Mr and Mrs R and L lane
10 Stanborough Mews
Welwyn garden City
Herts
AL8 6DB

Further to the recent planning application to extend the drive way to 10 Stanborough Mews I would like to make the following objections to the application to extend the driveway.

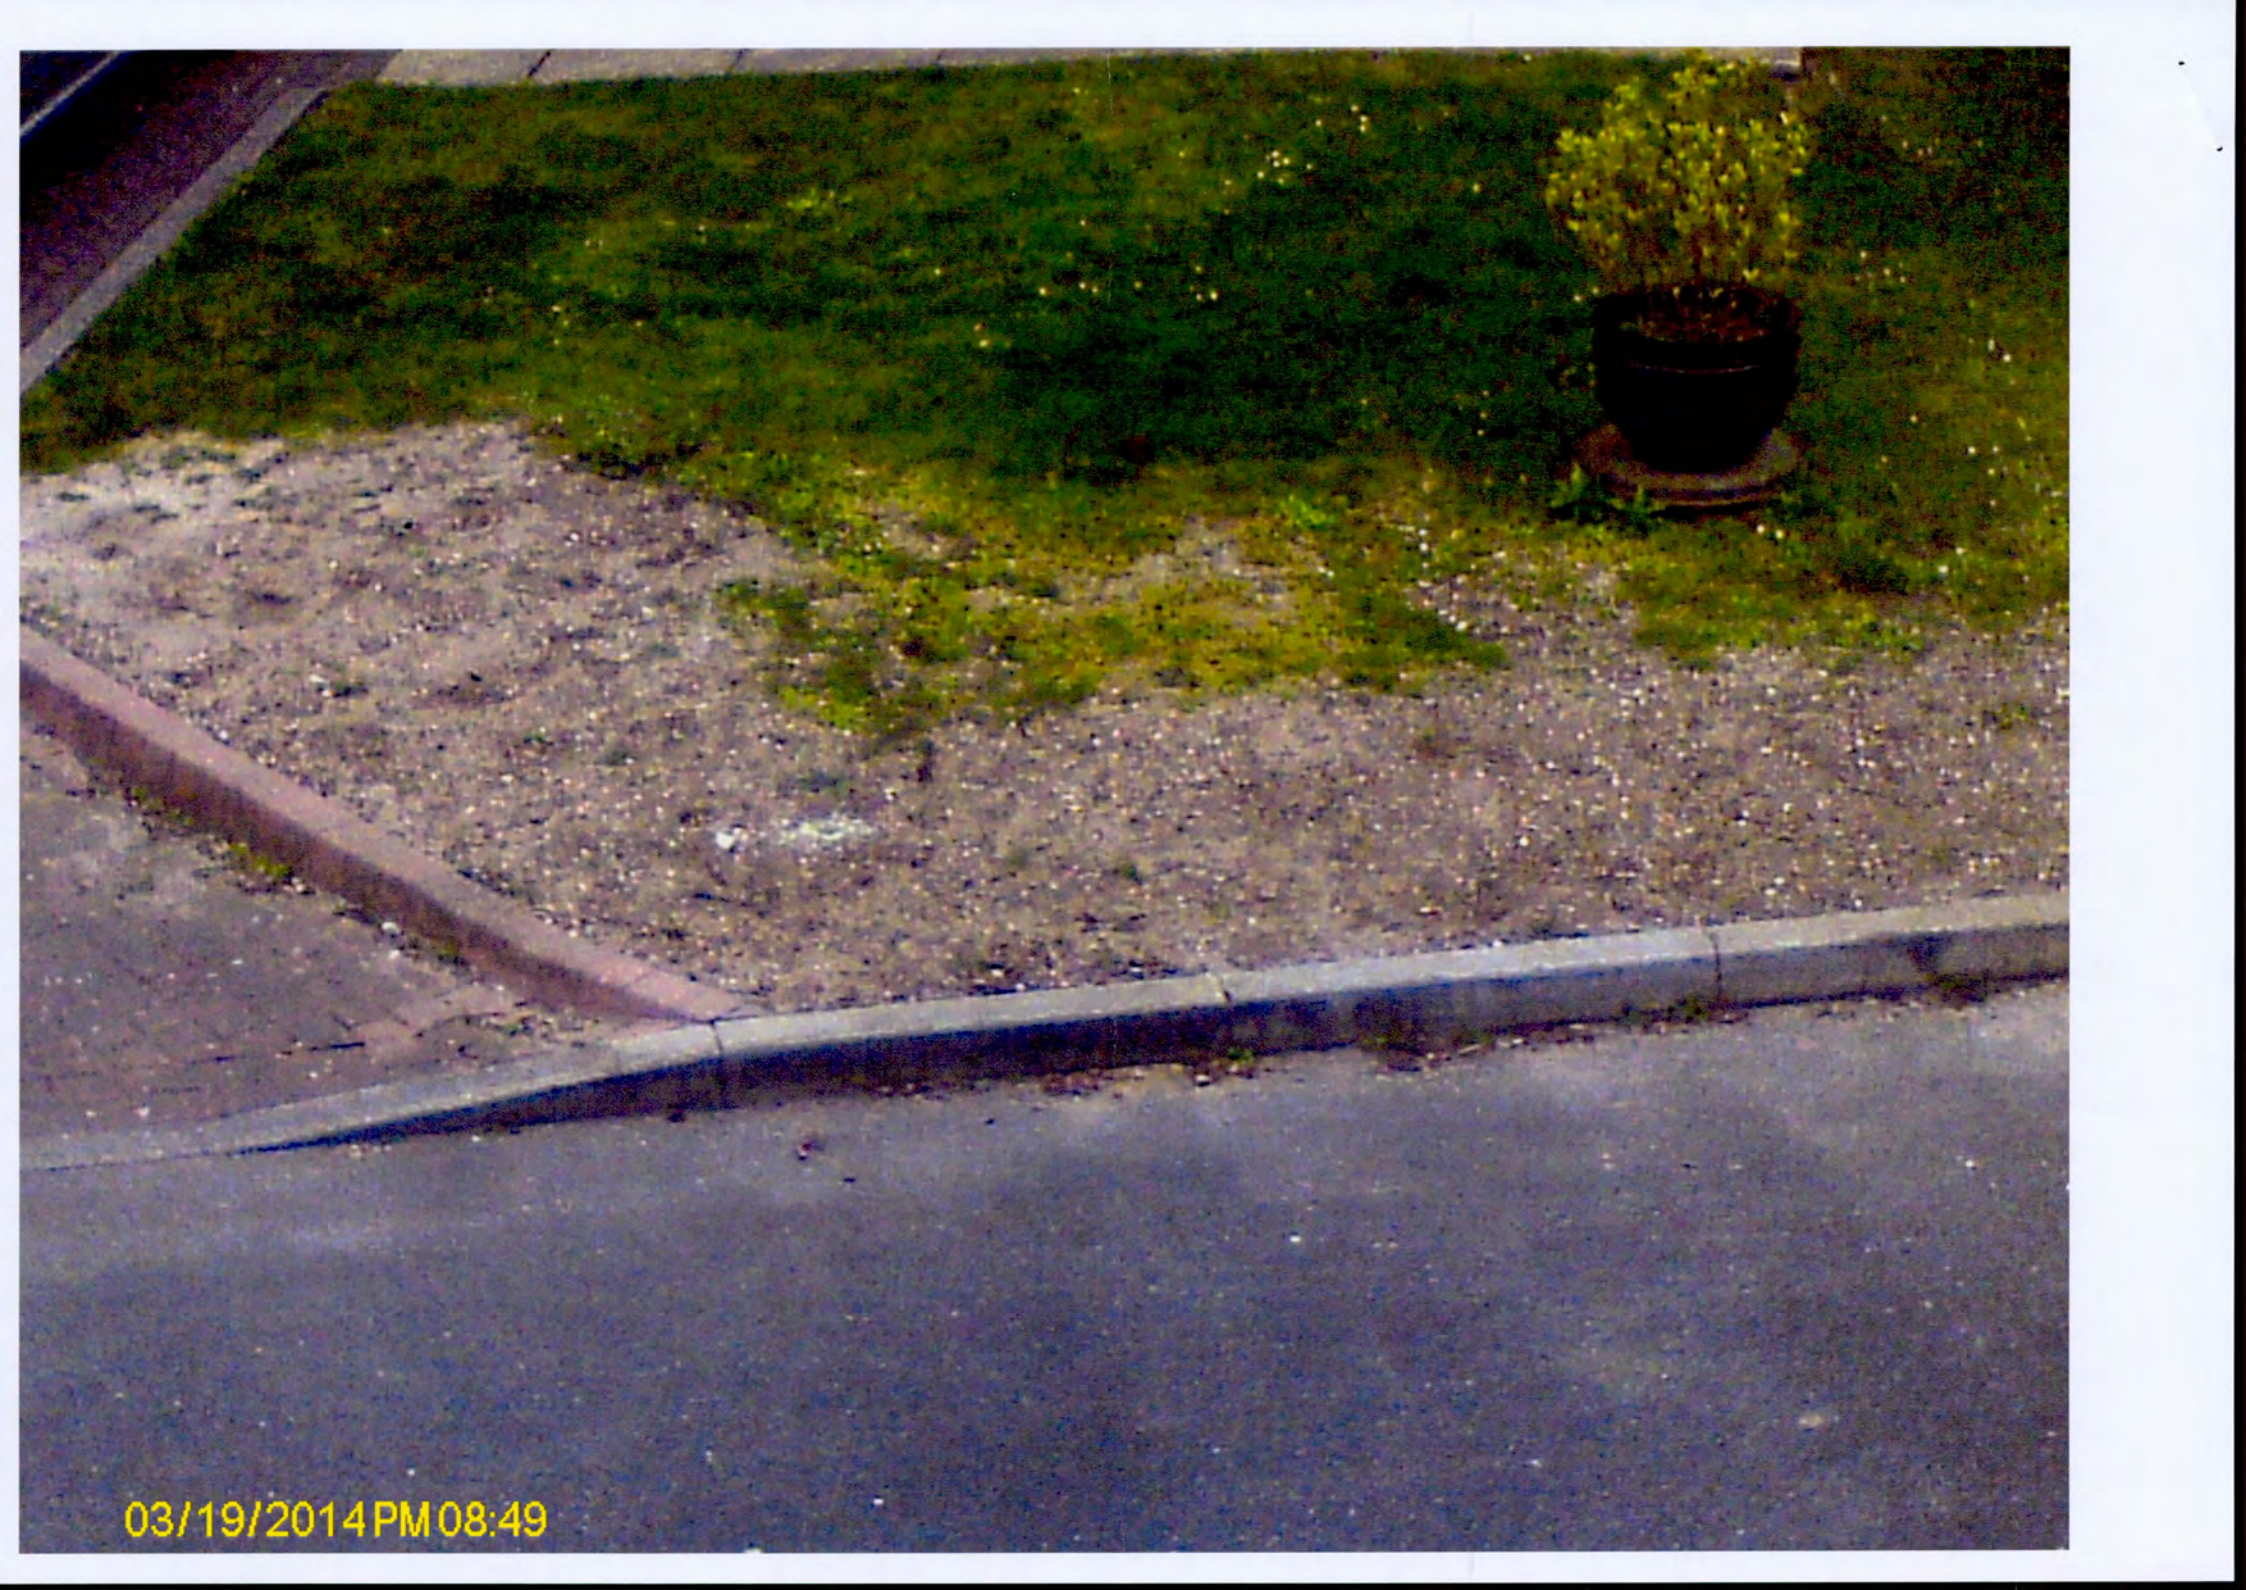
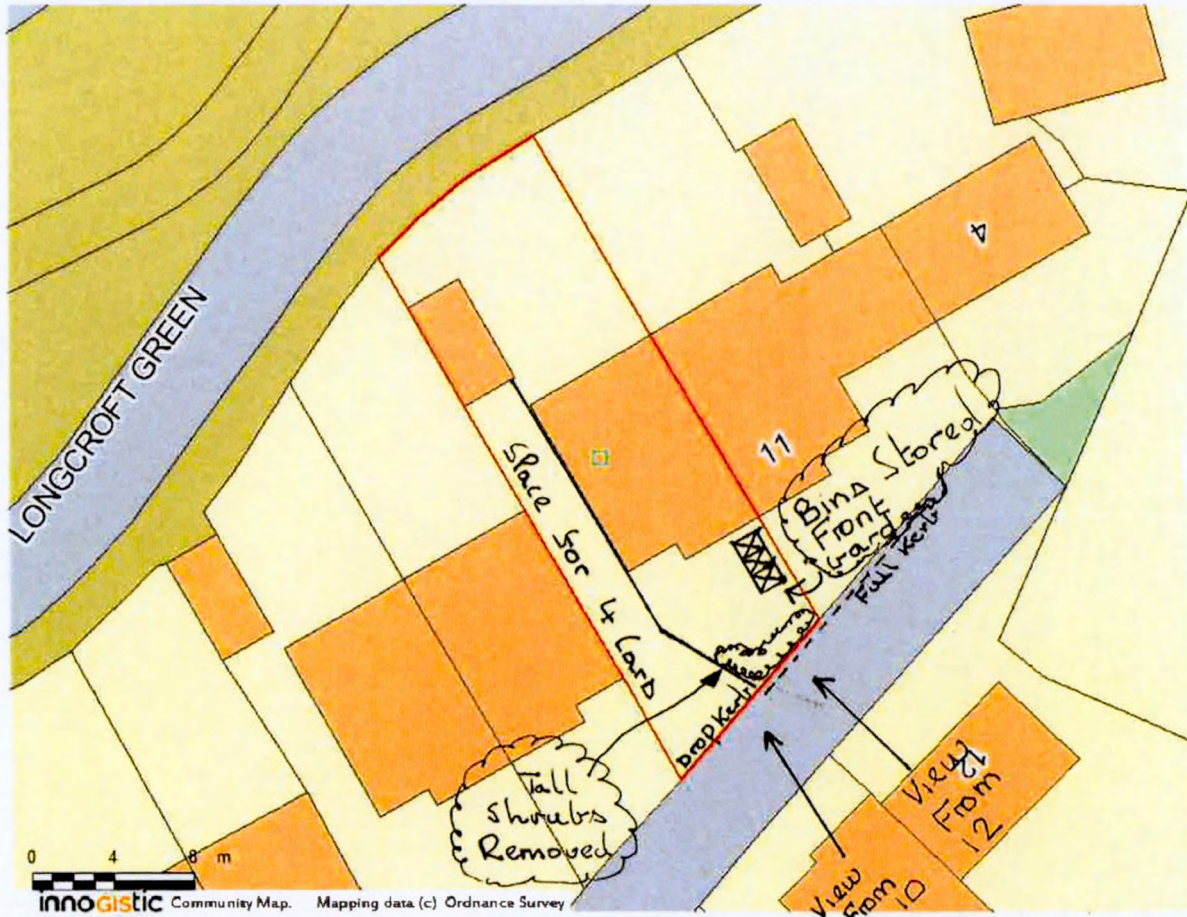
- 9) Visual impact more commercial vehicles will have on the street (see attached photos)
- 10) Considerations to be given to highway safety due to additional commercial vehicles delivering and collection materials and goods. (see attached photos)

View from 10 & 12
already effected as
Loss of Privacy due
To Shrubs being
Removed See photos

DRAWING 1 DRAINAGE AND KERB ISSUES

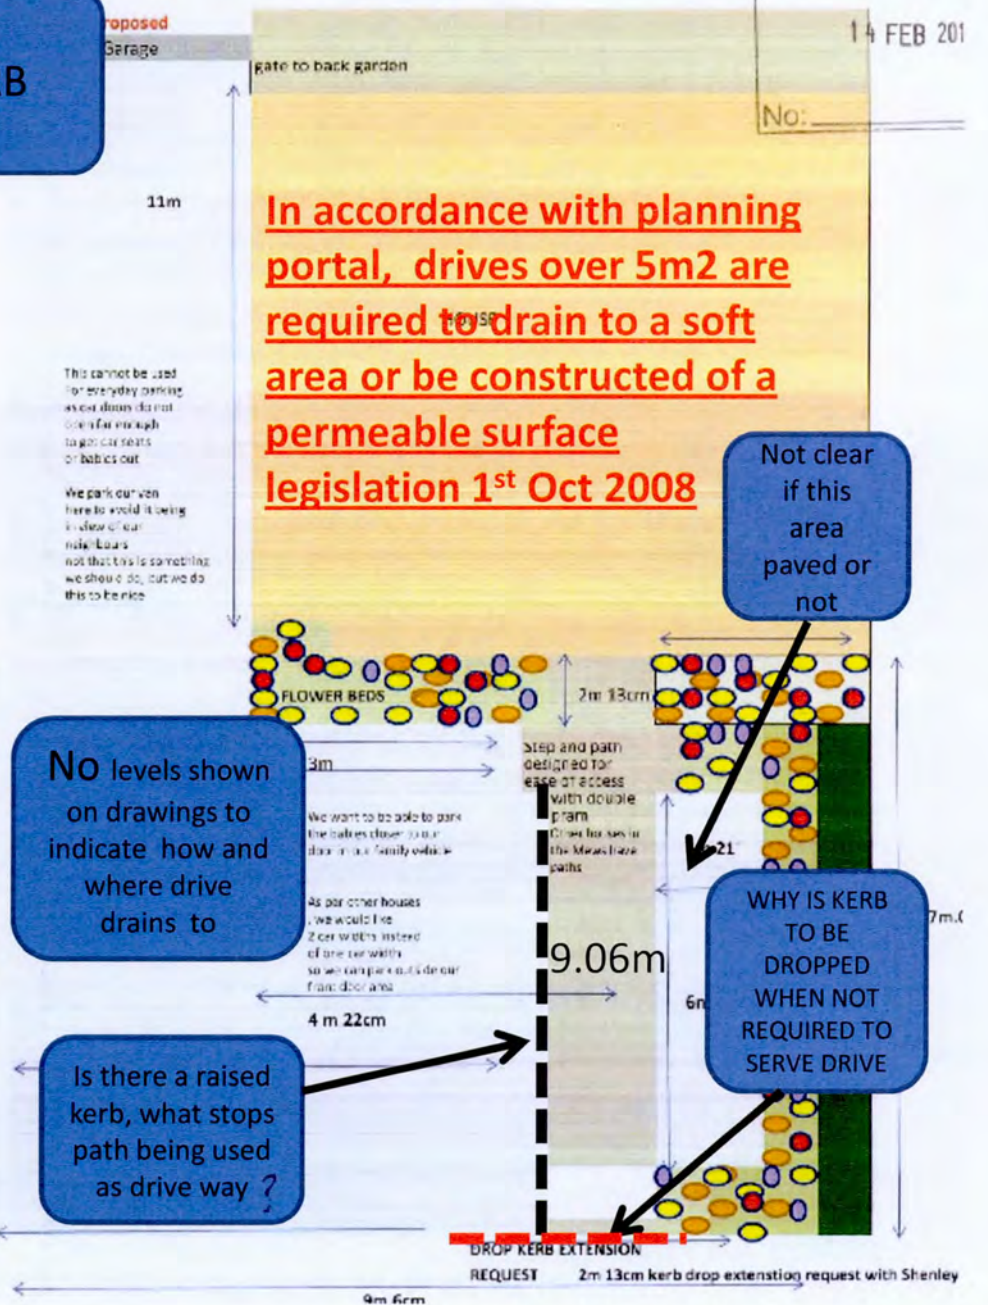
- 2) The planning application is not complete as the plan isn't to scale (1:50 or 1:100) therefore not possible to assess the full implications of the scheme, also noted there seems to be some dimensional errors on the drawing.

- 7) SUDS (Sustainable drainage systems) of driveways over 5m² should drain, according to latest regulations introduced on the 1st of October 2008, drain to a soft landscape area or be made of permeable surface, having studied the drawings it's not possible to ascertain how the driveway will be drained legally, as no levels have been annotated on the drawing or notes referring to the hard surface finish, therefore until this issues is clarified it would be wrong for the council to grant permission to extend the driveway.

DRAWING 2 Area and EM3 & 4 issues

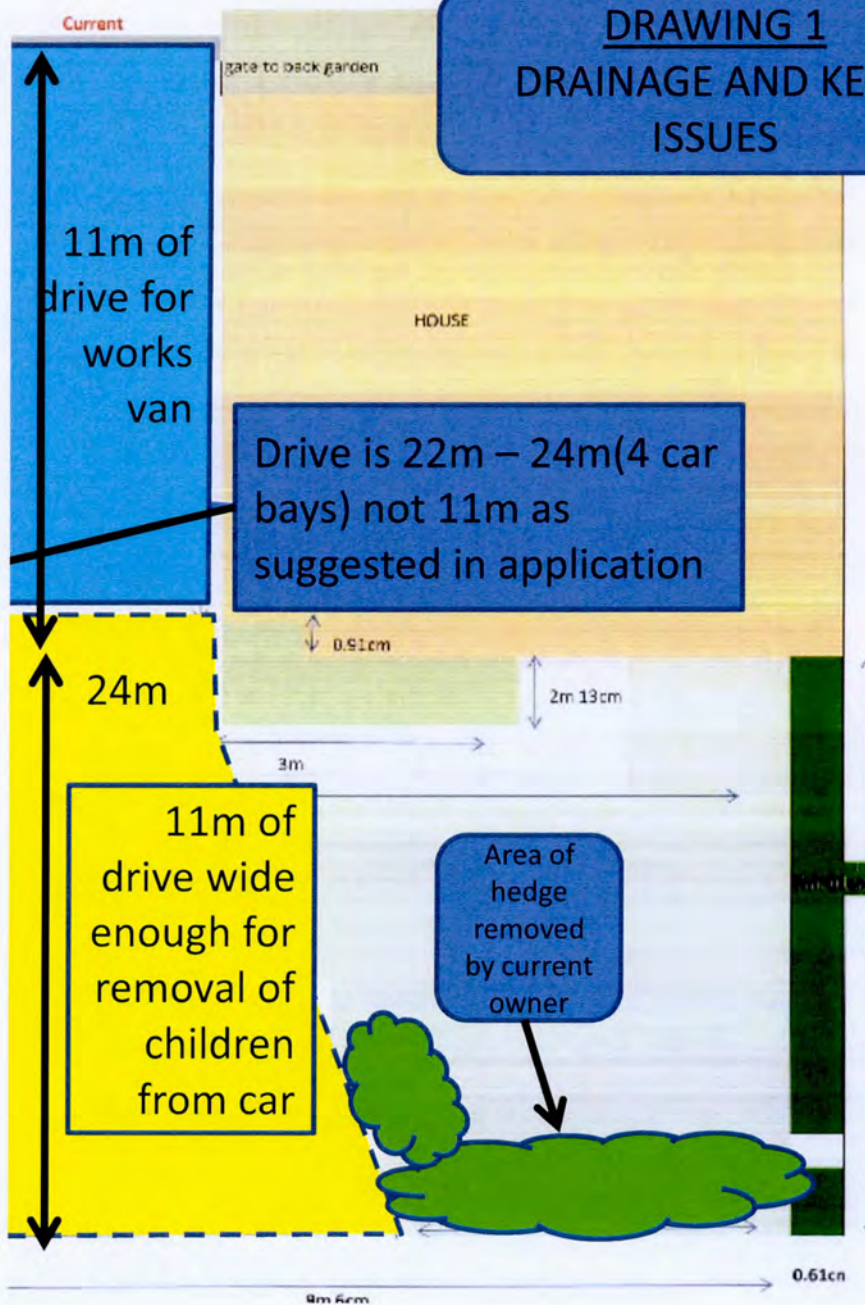
- 1) Policy EM3 has been contravened, re works to trees and hedgerows have already been removed prior to any planning approval. EM3 states works to hedgerows will only be allowed where the works would not result in loss of landscaping which would harm the character and amenities of the area. Please refer to the attached drawings and photos which indicate the areas of hedge removed and subsequent loss of privacy to 10 and 12 Stanborough Mews and detriment to street scene. In our view the character of the street has been fundamentally changed, we used to look out on to an appealing hedge/shrub scene, the new outlook from our kitchen and office is a patch of mud and dustbins. The removal of the hedge row is not conducive with council policy which states "the retention of frontages, hedgerows and trees are critical to preserve the character of the street and town. Policy states Consent is rarely given for the complete removal of the hedgerows without sound justification, I therefore would like the council to use all its powers to ensure the hedge row is reinstated as policy EM3 applies.

- 5) Policy EM4 contravened re proposals for hard surfacing for parking of PRIVATE vehicles in the front garden will only be allowed where works would retain an appropriate balance between

hard and soft landscaping and do not result in the loss of any existing hedgerows or landscaping along the BOUNDARY. Clearly too late as hedgerow has already been removed without permission.

Drawing not to scale re 1:50 or 1:1 as stipulated in item 4 WHBC application form.
